Access Compliance Report

Public Rights-of-Way

(Curb Ramps)

Intersection ID: N/A	Main Street: LANCASTER HWY	Cross Street: TRAFFORD PL	Location: E
ADA ID: 7280F0673580	Ramp Type: PerpDiag	Initial Pass/Fail: Pass	Overall Compliance: No
Codes/Mitigation Info/Possible Solution		Field Measurements/Component Compliance	
Severity Score: 7.5

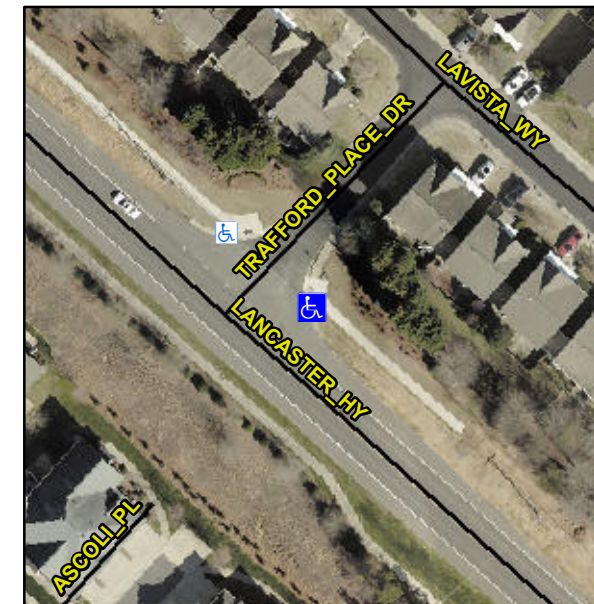
R304.2.1, R302.7.2

Remove & Replace Landing. Grind Gutter Lip.
